Inland Transport Committee

Working Party on Passive Safety

Fiftieth session

Report of the Working Party on Passive Safety on its fiftieth session

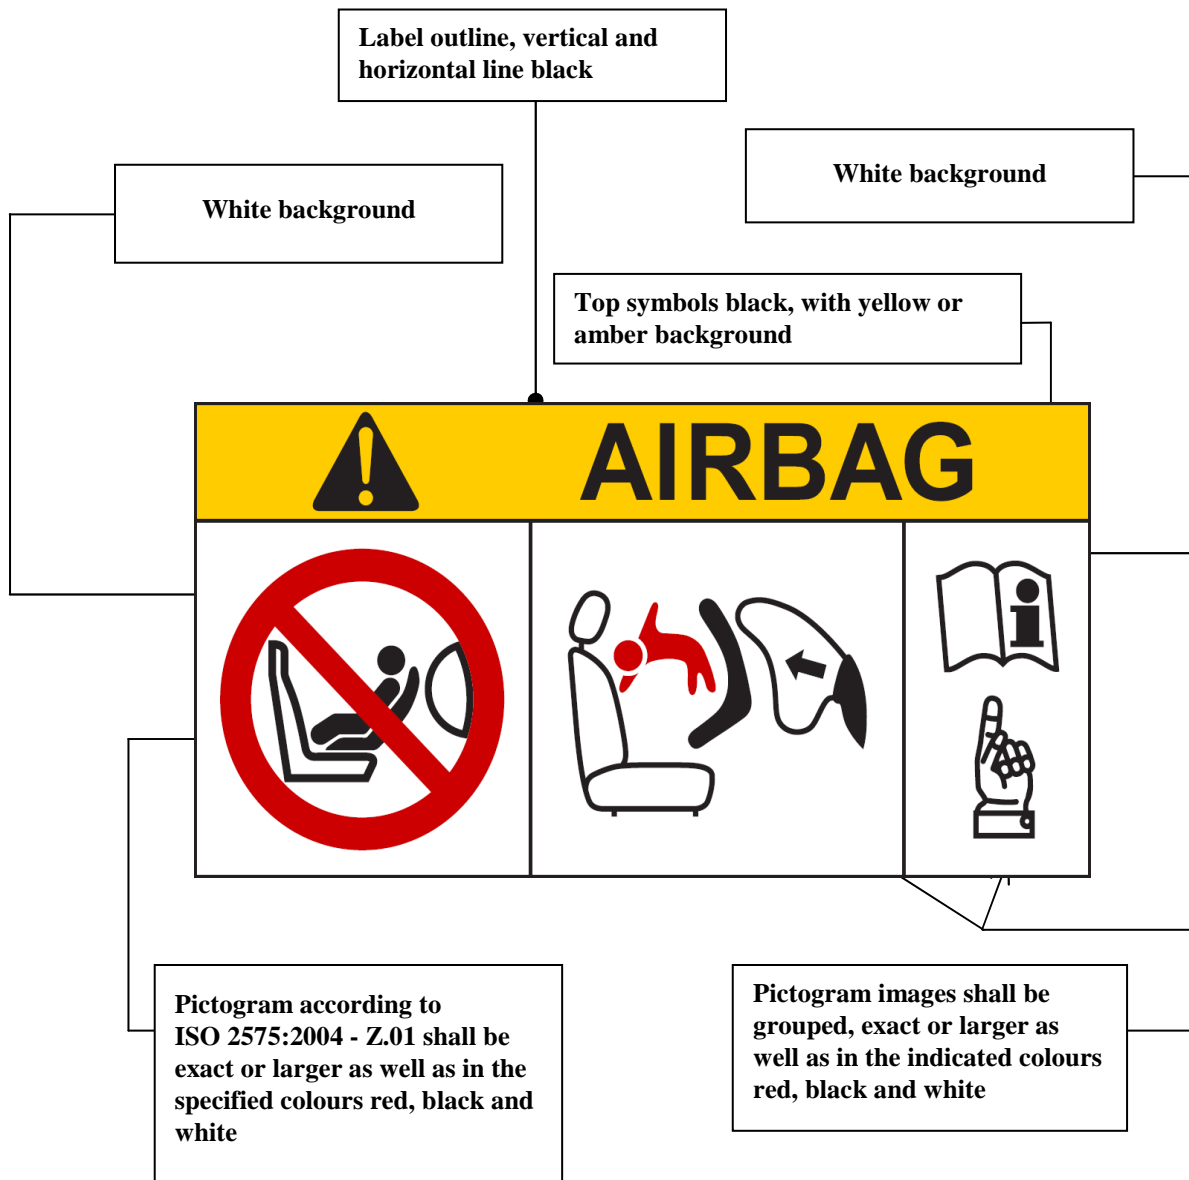
Adopted on the basis of GRSP-50-14 (see para. 27 of the report)

Paragraph 4.4., shall be deleted

Insert a new paragraph 4.4., to read:

"4.4. On the visible inner surface (including the side wing beside the child's head) in the approximate area where the child's head rests within the Child Restraint System, rearward facing restraints shall have the following label permanently attached (the information shown is a minimum).

Label minimum size: 60 x 120 mm.

The label shall be stitched to the cover around its entire perimeter and/or permanently bonded to the cover over its entire back surface. Any other form of attachment that is permanent and not liable to removal from the product or to becoming obscured is acceptable. Flag type labels are specifically prohibited.

If sections of the restraint or any accessories supplied by the Child Restraint System manufacturer are able to obscure the label an additional label is required. One warning label shall be permanently visible in all situations when the restraint is prepared for use in any configuration.

Paragraph 14.3.3., amend to read:

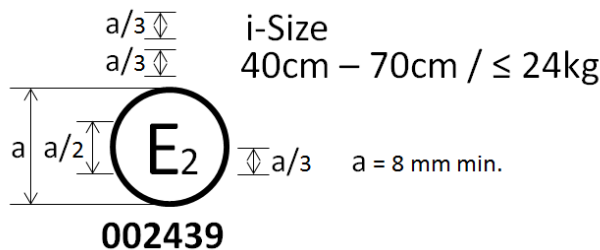
- "14.3.3. for forward facing Child Restraint System, the following information shall be clearly visible **on the exterior of the packing:**

"IMPORTANT - DO NOT USE FORWARD FACING BEFORE THE CHILD'S AGE EXCEEDS 15 months (Refer to instructions)".

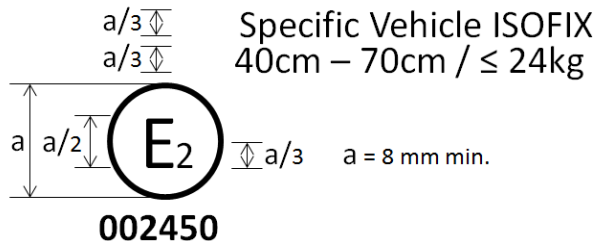
"Arrangements of the Approval Mark

The Child Restraint System bearing ...

The Child Restraint System ... concerning the approval of **specific vehicle ISOFIX** Child Restraint ... "

Appendix 2, amend to read:

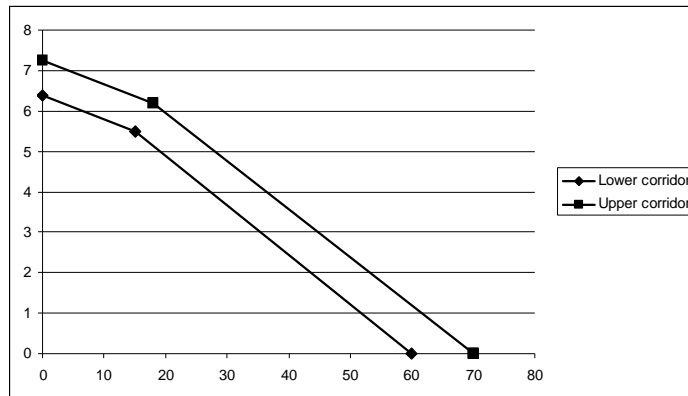
"...

The additional **segment applies** only for the acceleration sled."
